# **A G E N D A**

## **Architectural Review Board**

**February 28, 2023 – 5:30 p.m.**

2C

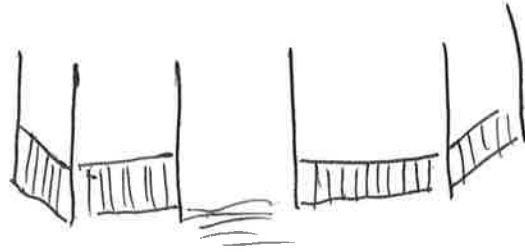
**REMARKS:** The petitioner is requesting permission to retain a 6’ wood, dog-eared privacy fence located on both sides of the house. Attached to the wood fence is a 6’ wrought iron fence painted black located in the front yard on both sides. The petitioner also requests permission to install a porch railing that will be 42” high with 1 1/2” x 1 1/2” pickets spaced at 5”. The top rail will be 2” x 4”. The porch rail will be painted white.

- A Board of Adjustment variance would be required if the wood privacy fence extends past the front of the house.
- A possible compromise may be to stop the wood fence at the front corner of the house and extend the wrought iron fence to that point. With plantings or bushes in front of the wrought iron fence, it may be appropriate.

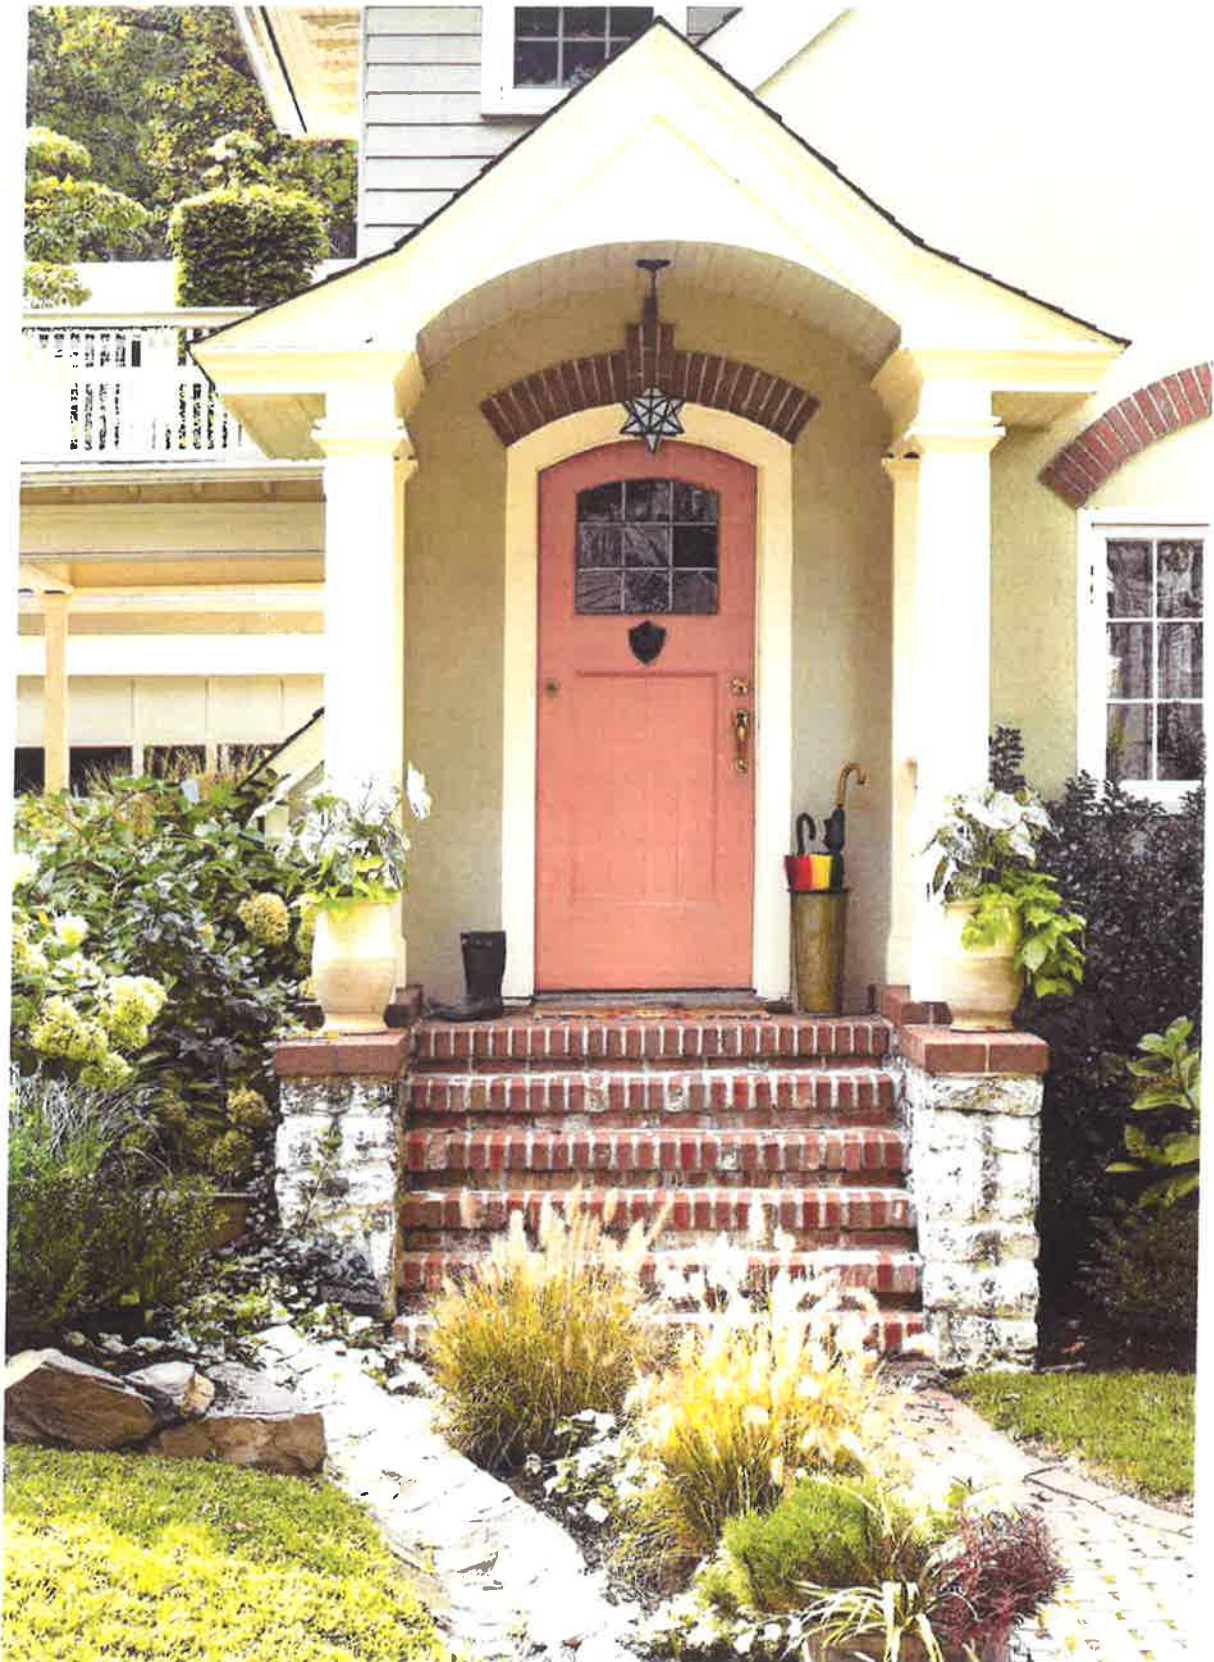
**REMARKS:** The petitioner is requesting permission for brick pillars on either side of the stairs on the right side of the house. The pillars will start porch height and angle down towards the driveway to follow the rise and run of the stairs. The steps will be covered in new brick and it will widen the steps slightly. The concrete walkway will be bricked. On the left side of the house, the entrance will have steps covered in new brick and the walkway will be bricked. The petitioner also requests to paint the new brick a color off the palette since the brick cannot be matched to the brick on the residence.

- No objection

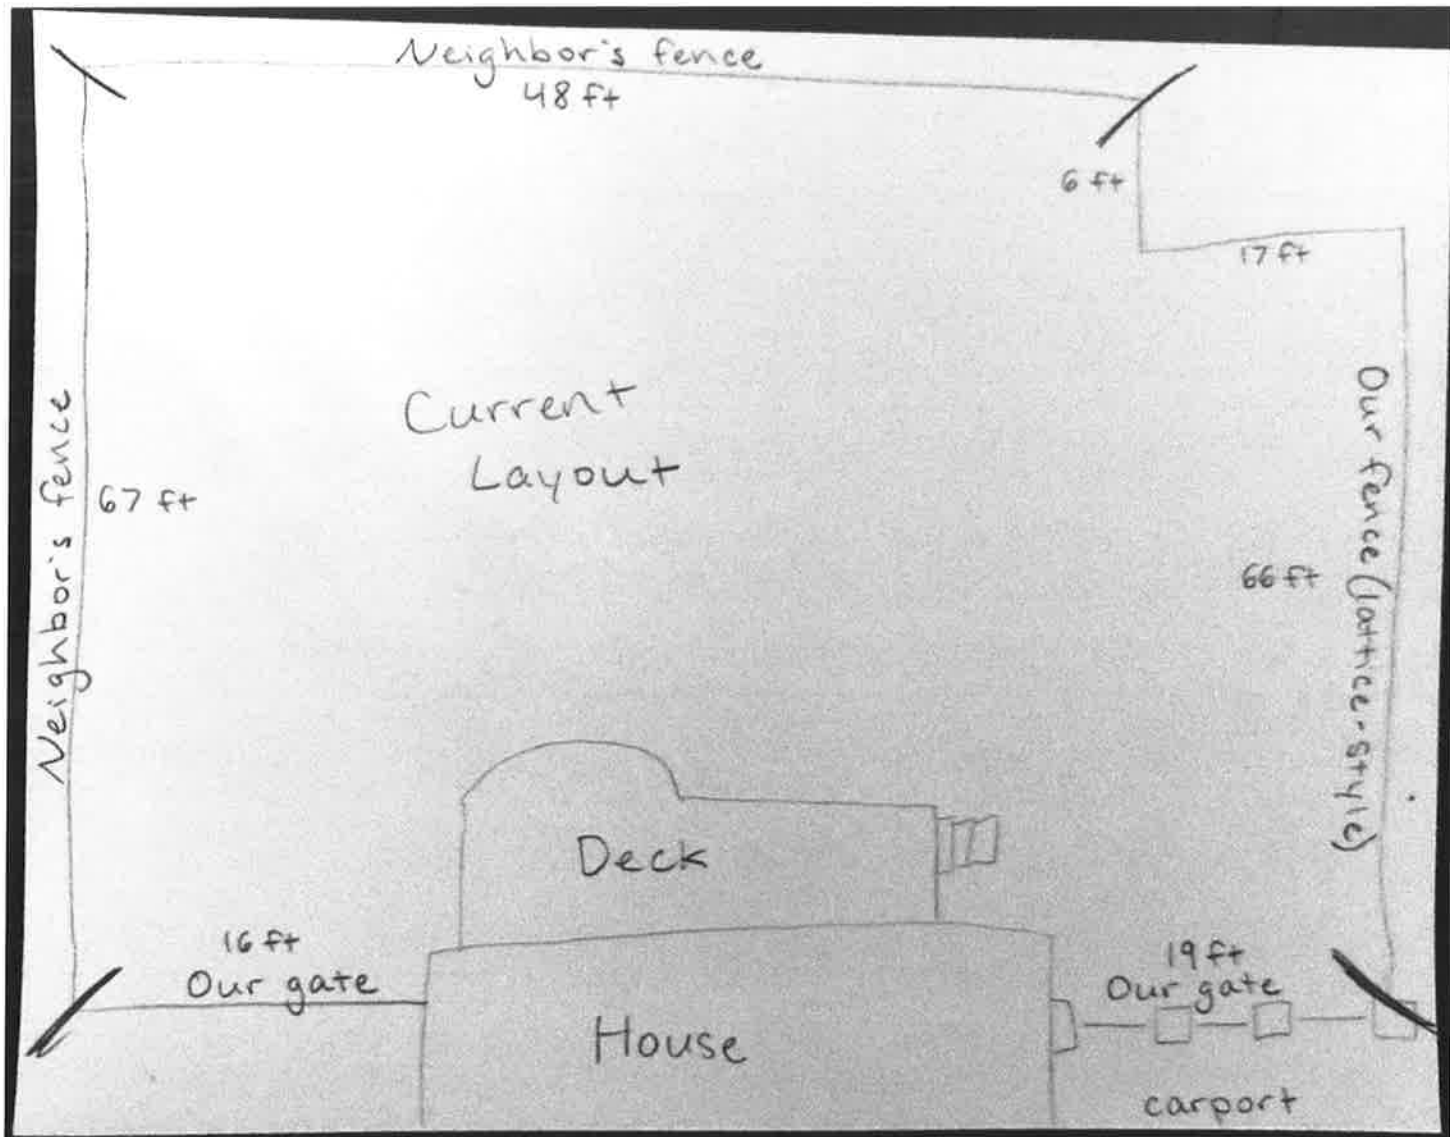
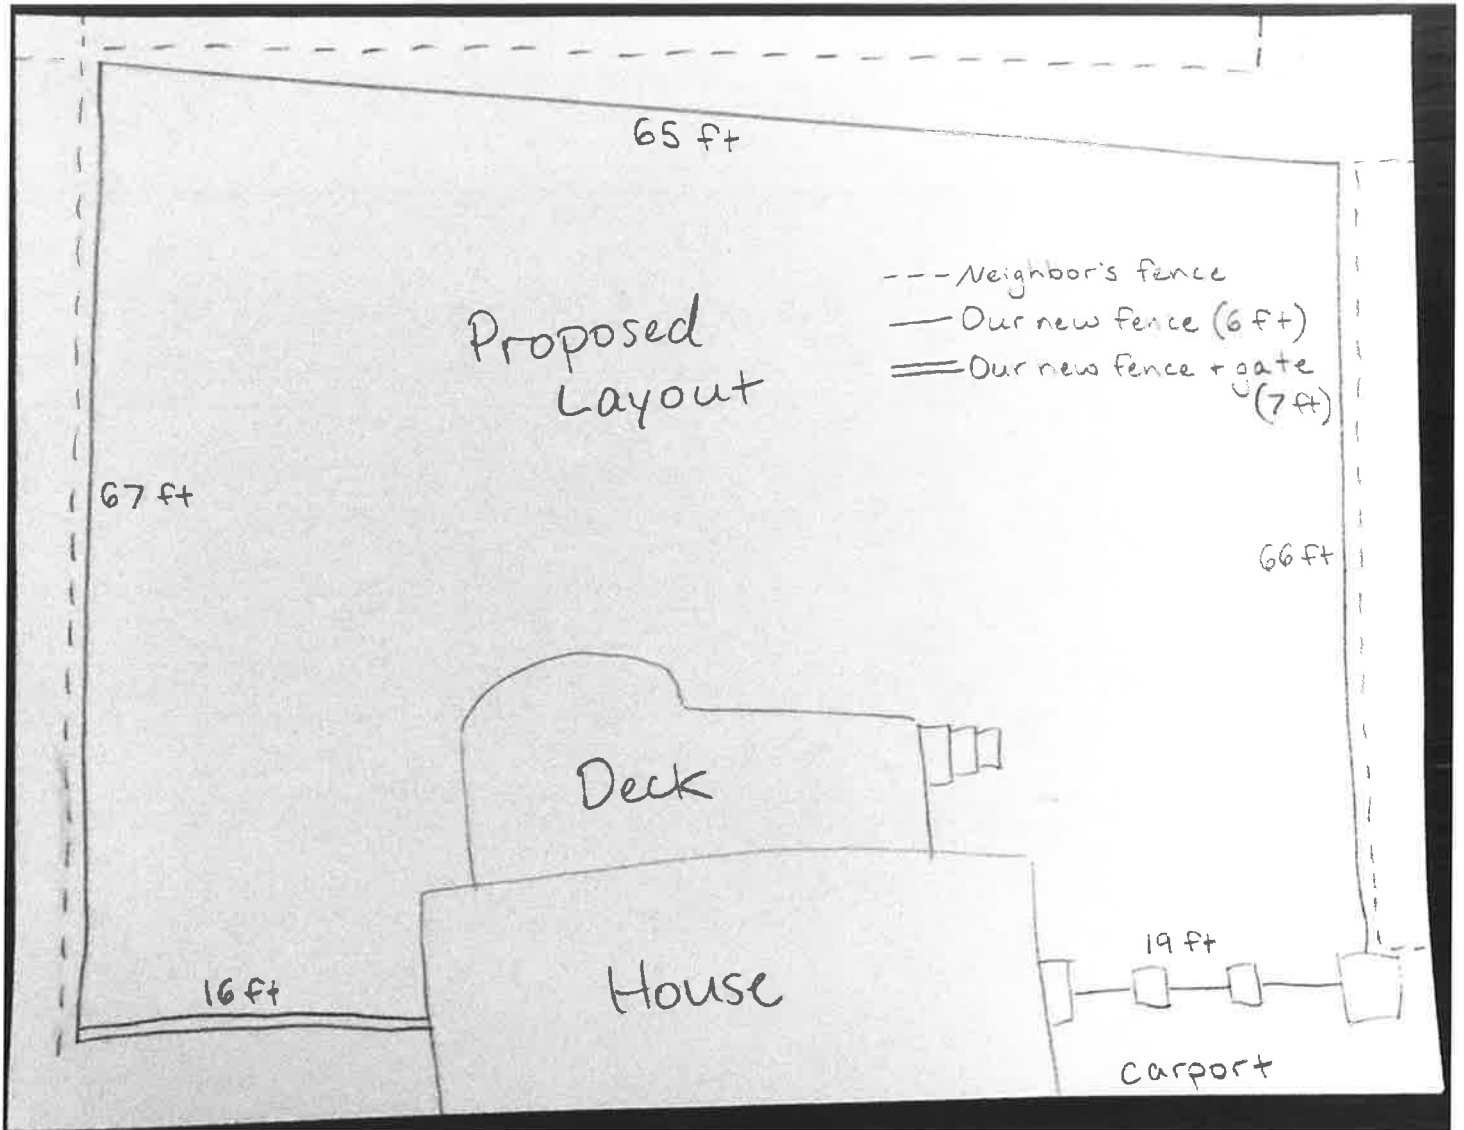
- install approximately 32’ of 6” aluminum K style gutters in various locations around the house. The downspouts will be placed to direct water away from the foundation of the house. The gutters will be painted to match the existing gutters and the trim of the house.

- install a 6’ dog eared wood privacy fence around the rear yard. The lattice fence on the right side of the yard will be removed. The fence along the rear and left side belong to the neighbors. The proposed fence section that is returning to the house on the left side is proposed to be 7’ with a gate for access and increased privacy.

- No objection to the privacy fence or gutters.
- A street-facing garage door is a mid-century modern addition to residential language in the US. The current carport is proportionate and well designed to the historic house. Enclosing it to make a garage would not be appropriate.
- Widening the driveway would have an adverse effect to the appearance of the house. Although it is an annoyance to stack and back cars into the street, your street is wide enough and substantially residential in nature that would accommodate that.

6T

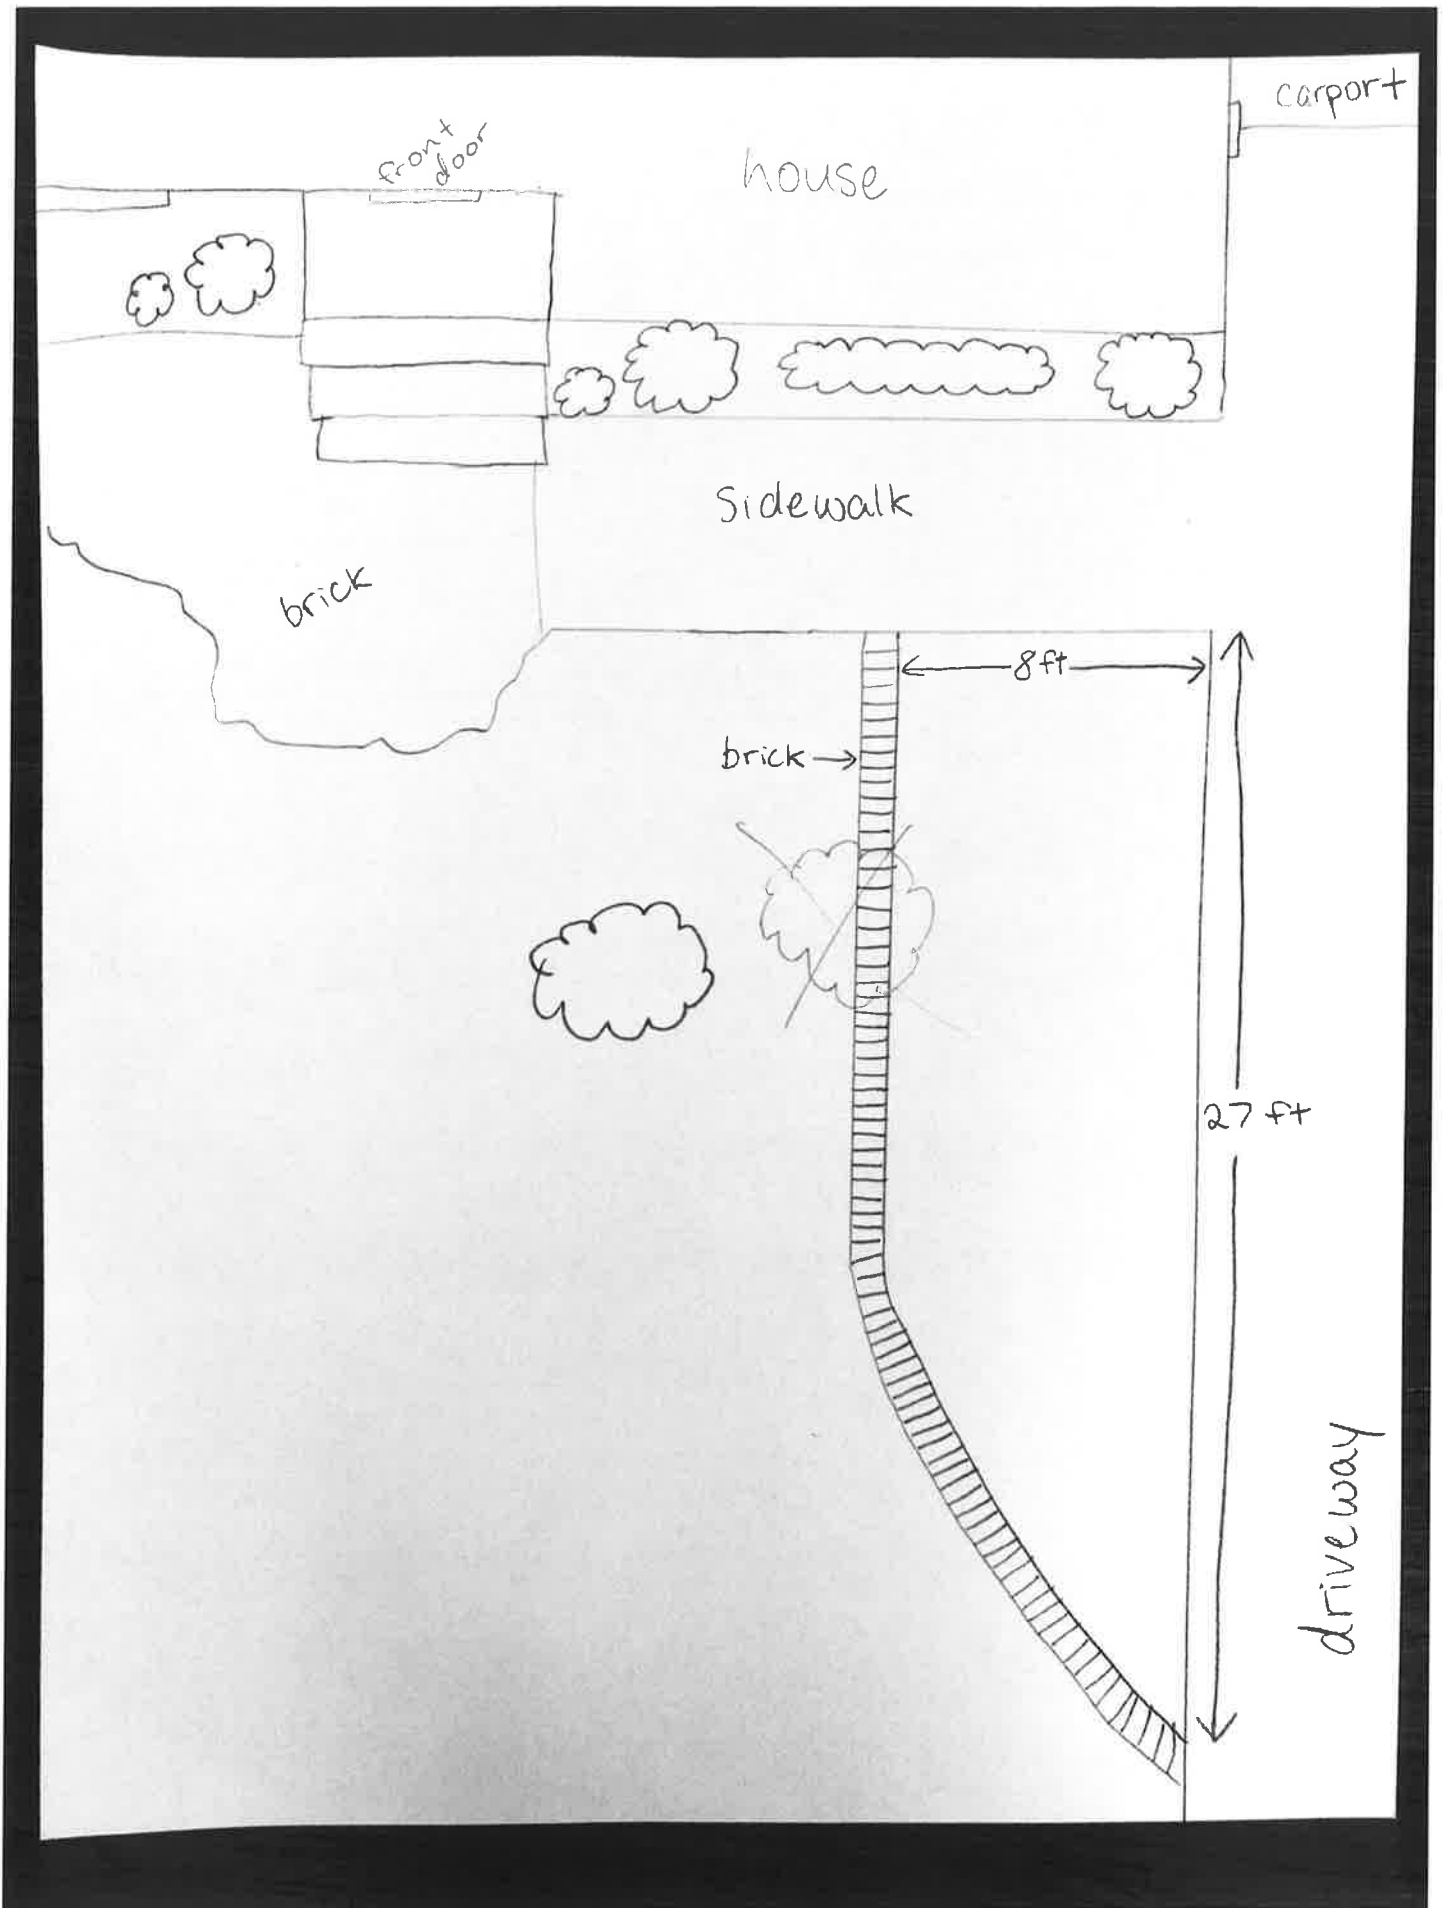
- would like to widen their current driveway by 8’ x 27’ to allow space for one car to park. It will be filled with crusher run gravel and outlined in brick to match the existing driveway.
